## **LABRADOR RUN SUBDIVISION**

APPLICATION NUMBER 3 DATE July 22, 2010

REQUEST Subdivision

# DETAIL SITE PLAN

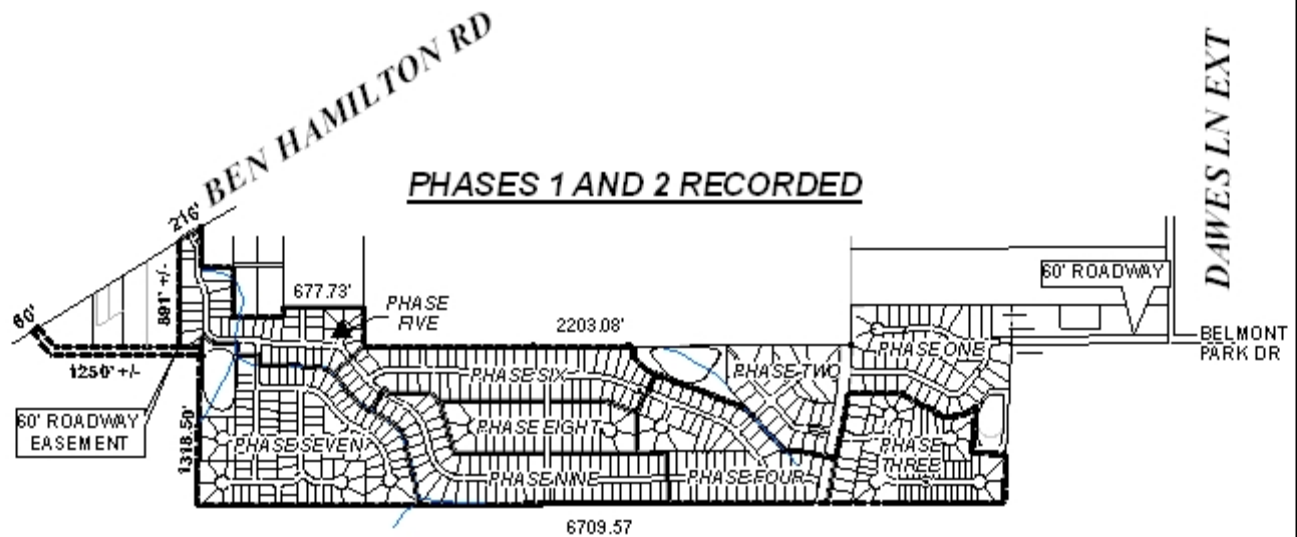
*The revised plat depicts existing Phases One and Two, as well as proposed Phases Three through Nine. There are 77 existing lots, and 413 proposed lots, for a total of 490 lots. The applicant proposes to create 71 lots with Phase Three. It should be pointed out that Phases One and Two are still not depicted as they were recorded, thus the overall plat should be revised to reflect Phases One and Two accurately, prior to the recording of any future phase.*

*The revised plat shows the requested street stubs to adjacent land-locked parcels, reflects the revised cul-de-sac diameters, resolves unaccounted for property, and includes required notes. The applicant has indicated that lot sizes and the 25-foot setback line will be depicted on each phase as it is recorded, as doing so on the overall plat would be difficult due to the number of lots within the development. The existing drainage/utility easement in Phase Five is not depicted, however, greenspace includes the same area: the final plat for Phase Five should show additional detail regarding existing and proposed easements, as should all other phases at the time of recording.*

*Seven large greenspace common areas are depicted, as are three large detention common areas. The plat has a note stating that maintenance of these areas is the responsibility of the property owners.*

*Finally, staff estimates that Phases Three to Nine contain  $176 \pm$  acres, however, the plat indicates that the site only contains  $157 \pm$  acres. The discrepancy should be addressed by the applicant and corrected on a revised overall plat prior to the signing of any future phase.*

*Based on the preceding, and with a waiver of Section V.D.2. for lot width, the revised plat is recommended for Tentative Approval, subject to the following conditions:*

- 1) *Provision of a Traffic Impact Study to the Planning Section of Urban Development for the entire development, and acceptance of that study, prior to the recording of any phase beyond proposed Phase Three;*

- 2) *Correction of the acreage information to ensure that the entirety of the development is accurately described on the overall plat;*
- 3) *Ensure that cul-de-sac rights-of-way and pavement diameters for Phases Three and higher comply with Sections V.B.14. (120-foot right-of-way diameter) and V.B.15. (96-foot pavement diameter) of the Subdivision Regulations, as shown;*

- 4) *Revision of the overall plat to accurately depict the recorded layout of Phases One and Two;*
- 5) *Ensure that street-stubs are provided to the land-locked parcel North of proposed lots 20-21 and 26-27 in Phase Five, and the land-locked parcel South of Phase Seven, in compliance with Section V.B.1. of the Subdivision Regulations, as shown;*

- 6) *Revision of any future phase plat to depict any existing drainage/utility easements associated with previous subdivisions (Lot 1, Duncan Subdivision) as well as proposed drainage/utility easements;*

- 7) *Revision of any future phase plat to identify the size of all lots in square feet, either via a table on the plat, or by the labeling of each lot, to ensure that each lot meets the minimum lot size identified in Section V.D.2. of the Subdivision Regulations;*

- 8) *Revision of any future phase plat to depict the 25-foot minimum building setback line, in conformance with Section V.D.9. of the Subdivision Regulations;*

- 9) *Identification and labeling of all common areas, including greenspaces, road medians, and detention areas, and placement of a note on the plat (overall and phase) stating that maintenance of all common areas shall be the responsibility of the subdivision's property owners, as shown;*

- 10) *Placement of a note on the plat stating that access to the 60-foot roadway easement on the West side of site is denied, as shown;*
- 11) *Placement of a note on the plat (overall and phase) stating that approval of all applicable Federal, state and local agencies is required for endangered, threatened or otherwise protected species, prior to the issuance of any permits or land disturbance activities, as shown;*

- 12) *Placement of a note on the plat (overall and phase) stating that approval of all applicable Federal, state and local agencies is required for wetland issues, prior to the issuance of any permits or land disturbance activities, as shown;*

- 13) *Placement of a note on the plat (overall and phase) stating that any lots which are developed commercially and adjoin residentially developed property must provide a buffer, in compliance with Section V.A.8. of the Subdivision Regulations, as shown;*

- 14) *Placement of a note on the plat (overall and phase) stating that submission of certification to Urban Development by a licensed engineer that detention facilities are adequate to comply with City of Mobile volume and discharge rate standards prior to signing of the final plat, as shown;*

- 15) *Placement of a note on the plat (overall and phase) stating that each lot is limited to one curb-cut, with the size, design and location to be approved by Mobile County Engineering, and to comply with AASHTO standards, as shown.*

- 16) *Provision of a revised overall plat for the development prior to the recording of the next phase (Phase Three).*
